SPEAKERPHONE SYSTEM—3-TYPE

2558D TELEPHONE SETS

CONNECTIONS AND MAINTENANCE

1.01 This section is reissued to:

Fig. 2—2558D Telephone Set—Speakerphone Connections

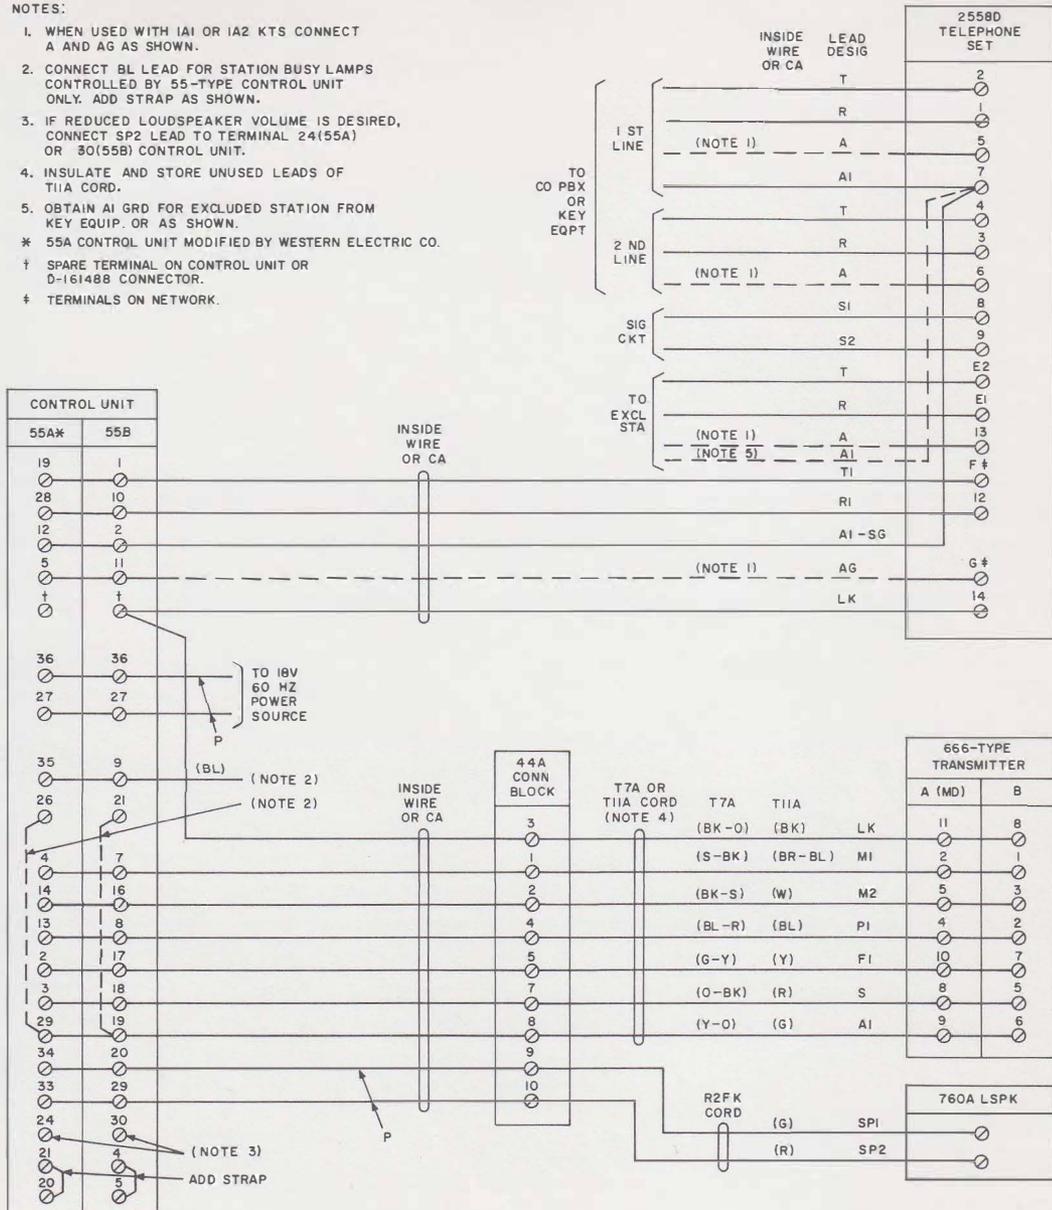
- Change section reference in 3.02.
- Include connections to 55-type control units which are marked 55A* to designate units modified by Western Electric Company to 55B control unit configuration and to show strap added between control unit terminal 4 and 5 (20 and 21 for 55A*).
- Show 666A transmitter MD, Fig. 2.
- Show current production sets not equipped with j-k line switch contacts and associated leads.
